ADDENDUM NO. 1

DATE: 5-28-2024

TO: ALL BIDDERS
FROM: JKF ARCHITECTURE
RE: Lenoir Community College New Aviation Center for Excellence
Project No. 2022-18

To: ALL BIDDERS
From: ATLANTEC ENGINEERS
RE: LENOIR COMMUNITY COLLEGE NEW AVIATION CENTER FOR EXCELLENCE
JKF Project No. 2022-18
Atlantec Project No. 22183

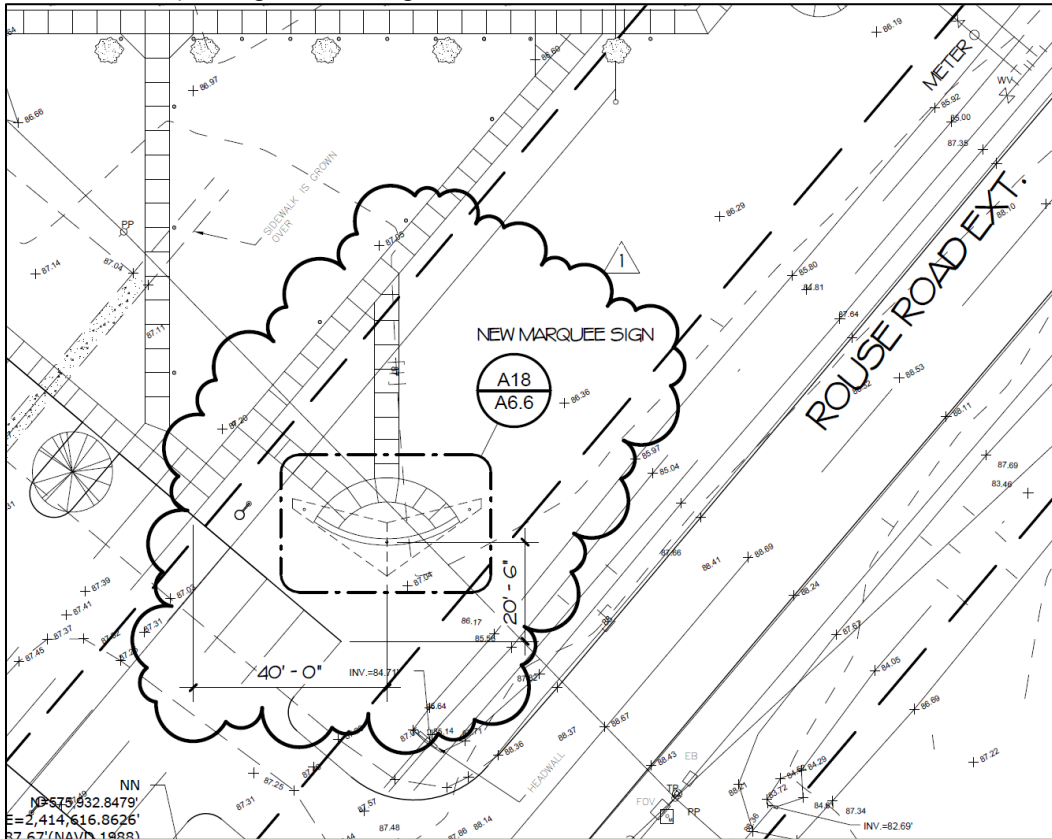
1. Drawing A1.11 and Drawing A5.11, dated 2-28-2024; Add 6" stud wall as follows:

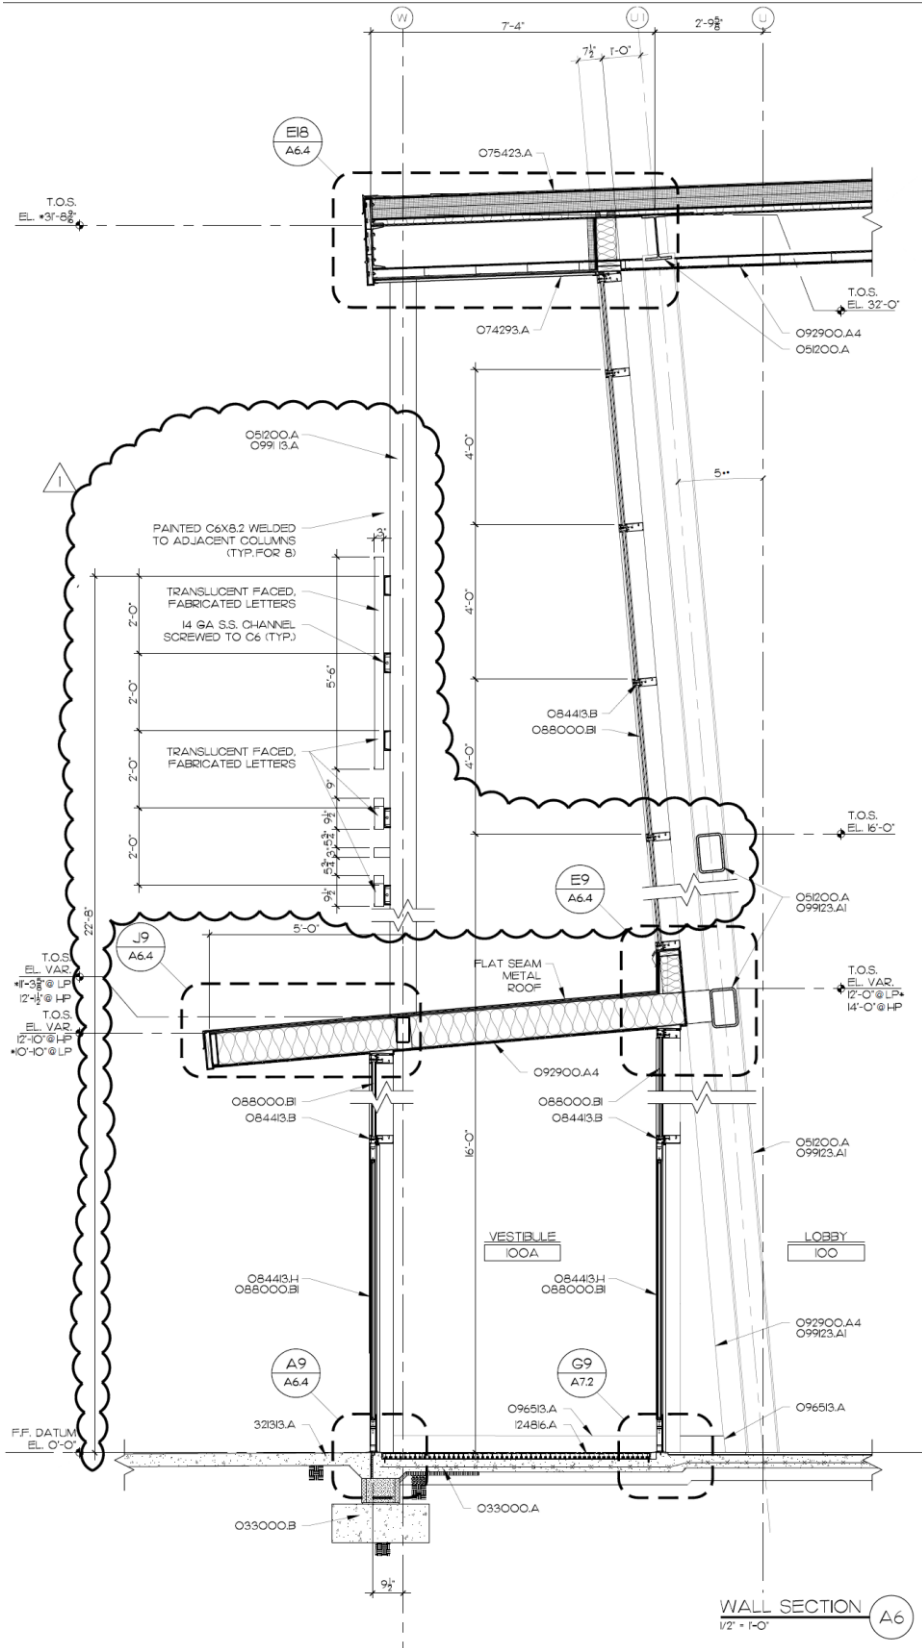
9. Drawing A9.11 and Drawing A9.21, dated 2-28-2024; Change Room Finish Tags B1 and B2, Floor finish from "RT" to "T".
10. Drawing A3.3 dated 2-28-2004; Revise Wall Section A6 as follows:

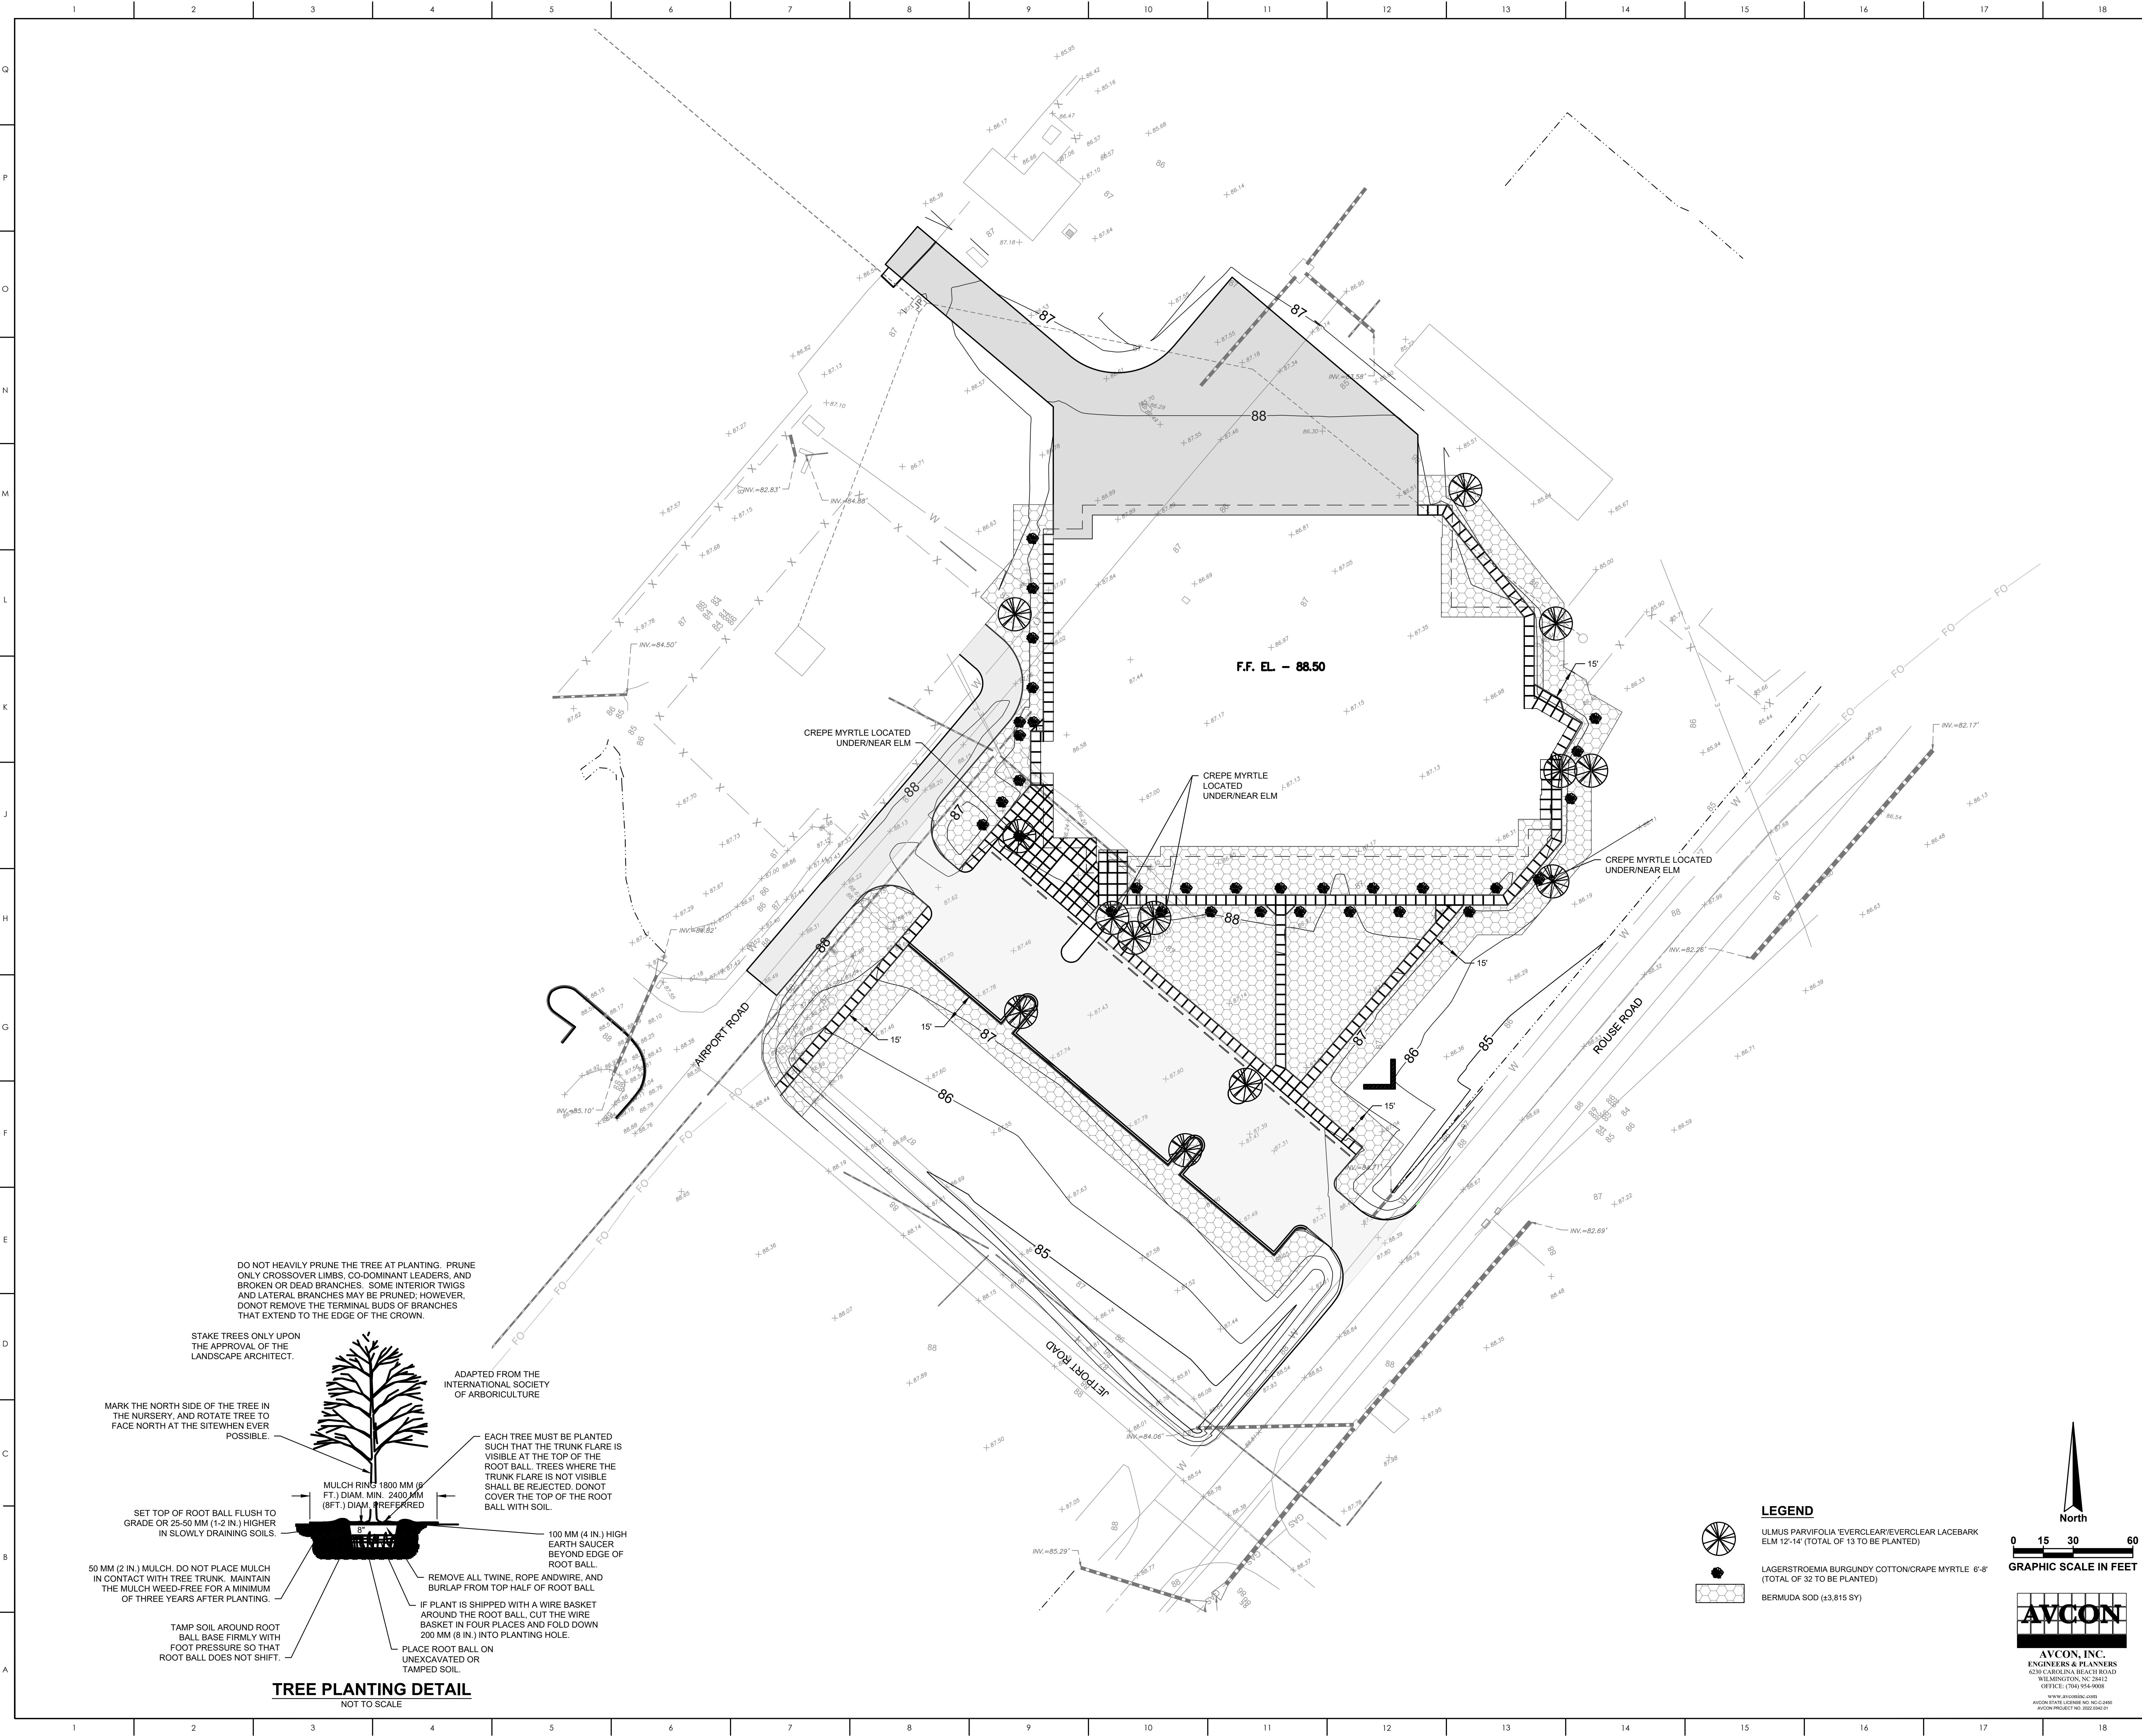
15. The contractor shall furnish and install a HYFAB MVP-630-460 domestic booster pump on the incoming domestic water system (See sketch for location). The pump shall be 3 HP at 460/3. Equal pump systems by Grundfos and Taco are acceptable. Provide all labor and material required including a Wessels FXA hydro-pneumatic tank. Equal hydro-pneumatic tanks by Grundfos and Amtrol are acceptable.
